INDEPENDENT ORBITER ASSESSMENT

ASSESSMENT OF THE FMEA/CIL INSTRUCTIONS AND GROUND RULES

14 OCTOBER 1986

WORKING PAPER NO. 1.0-WP-VA86001-01

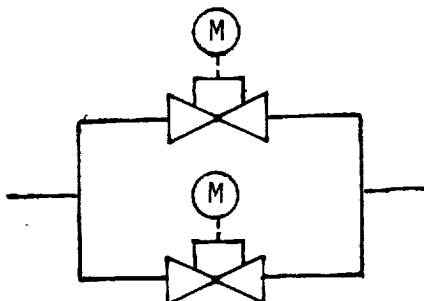
Problem: No provisions exist in Rockwell 100-2G to assure that FMEA/CIL identified failure modes are detected during ground turnaround. The Preliminary Draft of NSTS 22206 contained a provision to maintain a OMRSD matrix to track FMEA/CIL items against the OMRSD. Although the matrix was not adopted as part of the approved NSTS 22206, Basic, it will be maintained as an independent entity and will make reference to the FMEA/CIL identified items. In-flight verification of redundancy and the assurance that failure modes do not exist is at least as important as ground turnaround.

Recommendation: It is recommended that a matrix similar to the OMRSD matrix be adopted to provide tracability between in-flight checkout and critical items, to provide an awareness by both the crew and the ground in advance of potential problems.

Figure 3 - NSTS 22206 (Figure 1) FMEA/CIL Screening Process

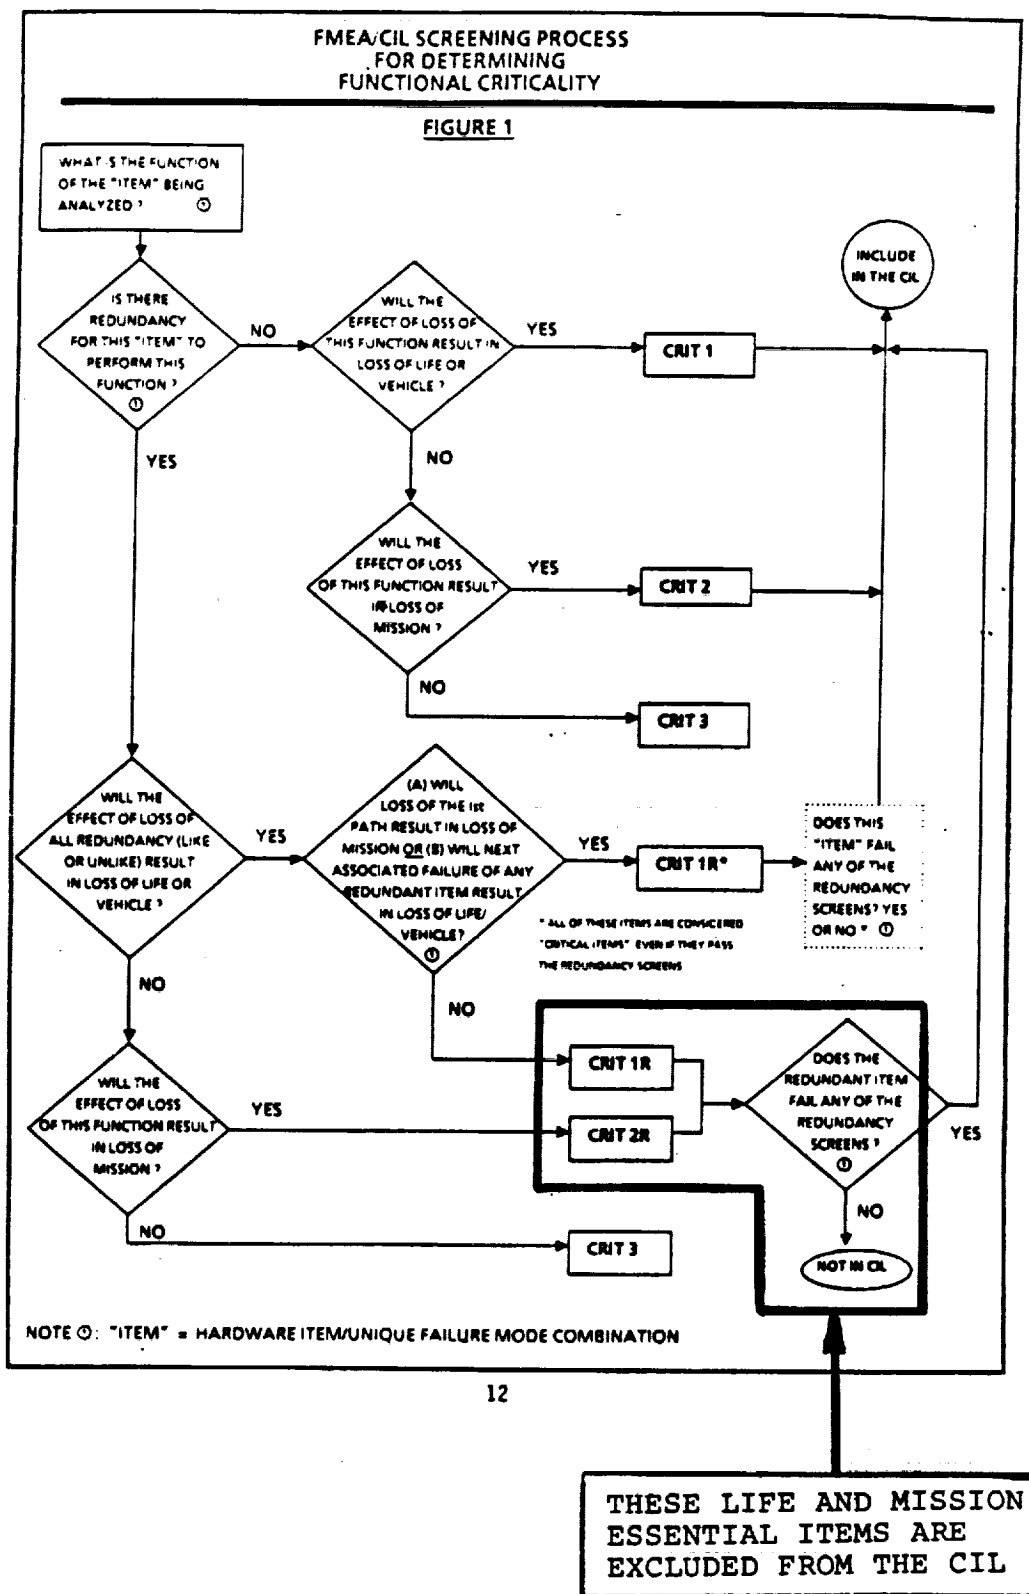
Problem: This figure is a logic road map for defining which orbiter items appear on the CIL. Two criticality categories are used: functional (which does not consider redundancy) and hardware (considers redundancy). Items that perform critical functions, but meet defined redundancy levels, and pass screens and are excluded from the Critical Items List (CIL). This exclusion creates a void in the control/assessment process. Attention and controls during manufacturing, assembly, test, failure reporting, corrective action review, and flight readiness reviews are less effective when all hardware that performs critical functions is not considered or treated. As a result, potential problems (latent manufacturing/design defects) with hardware may slip through the assessment process without management knowing the seriousness of the effects of failure.

Recommendation: Based on the Presidential Commission Report's position on management awareness, it is our recommendation that all automatic ground rules for excluding functional criticality 1R or 2R items from the CIL be eliminated and that, if items are to be eliminated, they be brought forward to the NSTS Program Level II change board for approval. In support of this position, it is recommended that the figure be replaced with a new figure shown as "Streamlined" replacement. Hardware criticality, in NSTS 22206 Figure 1, is replaced with a notation showing how many paths are available to accomplish the critical function.

FIGURE 1

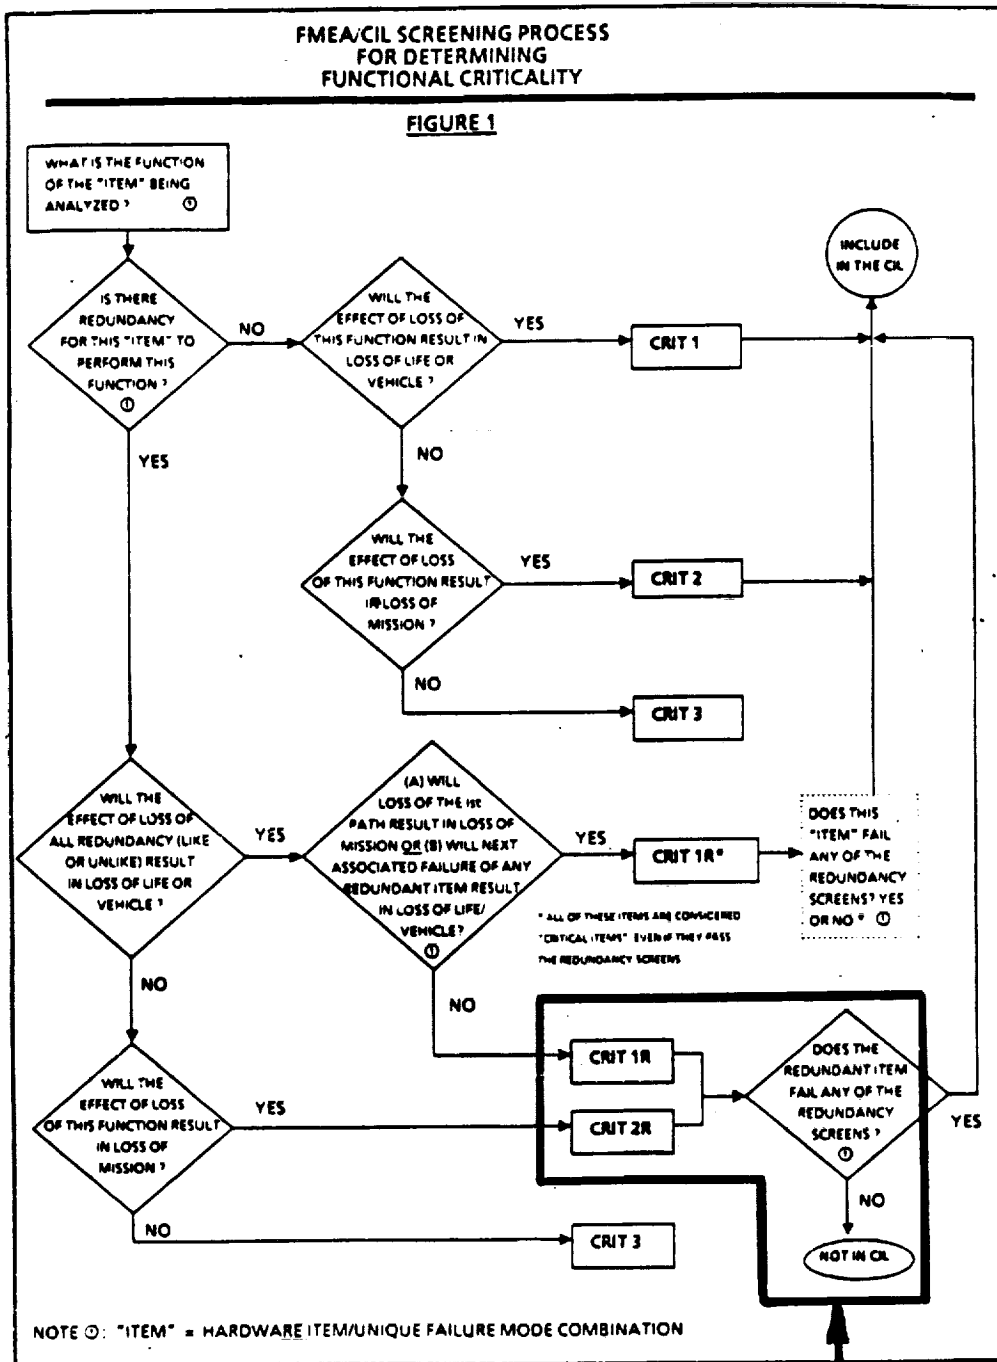
(REFERENCE) RI, 100-2G, FIGURE 10; NSTS 22206, FIGURE 1
